**CRANBERRY CREEK SUBDIVISION (PHASE TWO)  
CREATING SUBLOTS 56 THROUGH 90 and BLOCK C**

**Case No.** 17-27  
**Reviewed By:** Haley Wachholz  
**Date Submitted:** 9-12-17  
**Due:** 10-11-17 (ext. of time until 11-8-17)

**REPLAT OF SUBLOTS 13-R & 14,  
OF THE CUYAHOGA VALLEY HOMESITES  
SUBDIVISION No. 1**

**REPLAT OF BLOCK B-R5,  
WINTERGREEN POINT SUBDIVISION**

**Exhibit 2**  
**Replat**

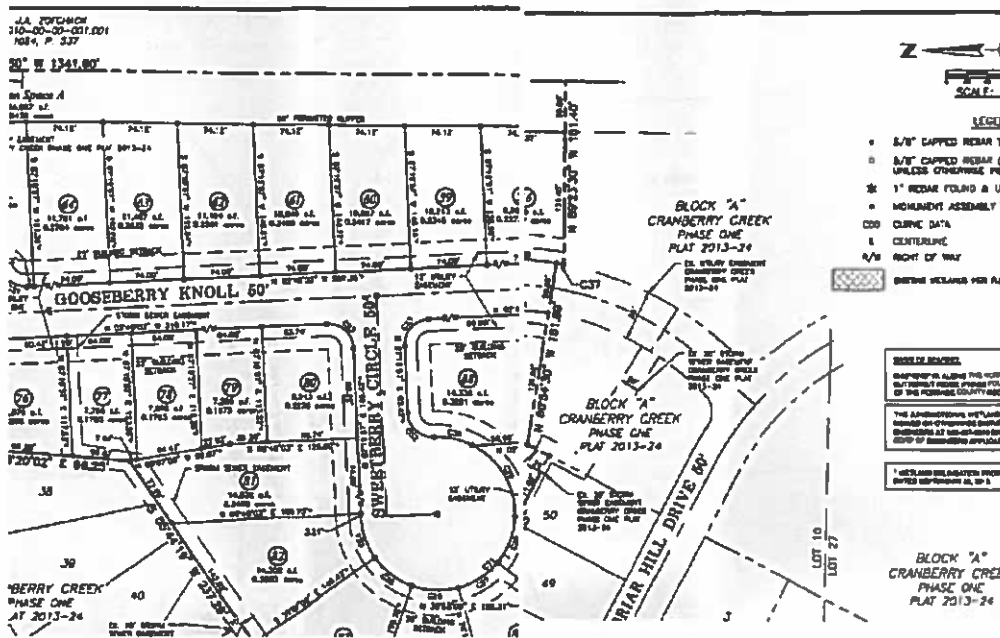
316.3- Surveyor, registration seals & numbers

- 316.16- Certification by registered surveyor
- 316.17- Copy of deed restrictions
- 317.1- Approval by zoning inspector of covenants & restrictions for Home Owners Assoc. (needs signed)
- 317.2- Required improvements have been installed and approved by proper officials or agencies.
- 317.4- Vicinity map (1"=1000 or 1"=2000)
- 320.3- Notarial acknowledgement

Exhibit 2  
Replat

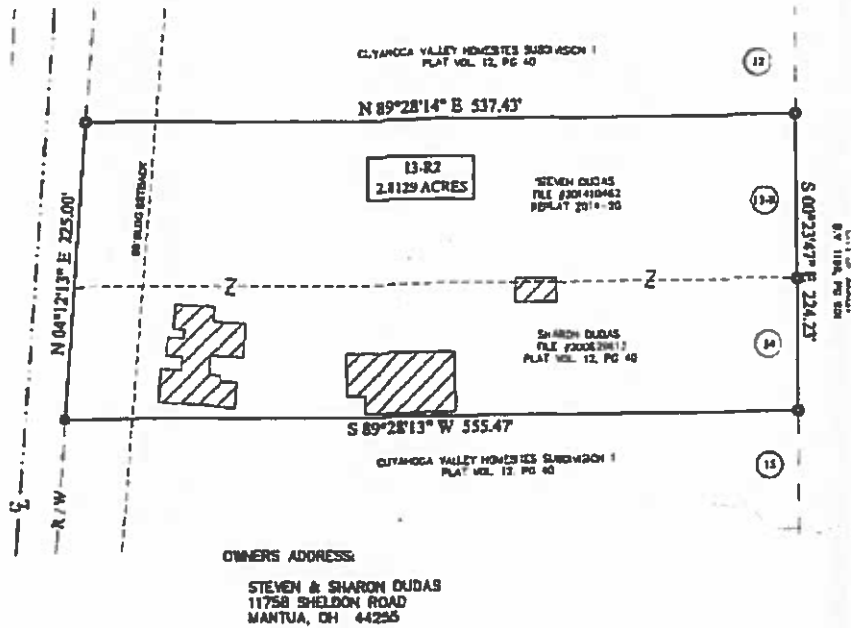
316.24- Approval of Tax Map

**ANALYSIS:** This replat will fulfill the combination of 2 sublots into one. There are no physical restraints on this property and the comments are in regard to Tax map and zoning approval. Conditional approval by Tax Map is due to several minor labeling errors.

**Exhibit 2**  
**Replat**

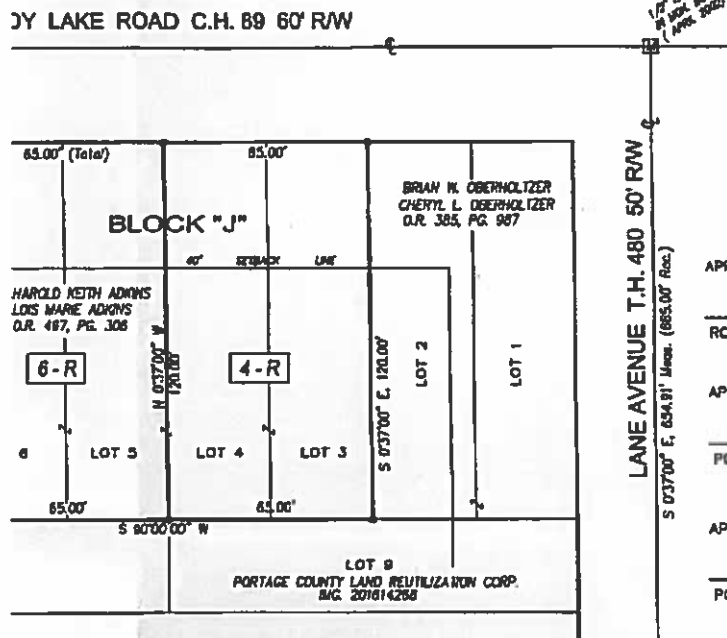
316.24- Approval of Tax Map

**ANALYSIS:** This replat will fulfill the combination of 4 sublots into two buildable lots. There are no physical restraints on these properties and the comments are in regard to Tax map and zoning approval. Conditional approval by Tax map is due lack of North Bearing.
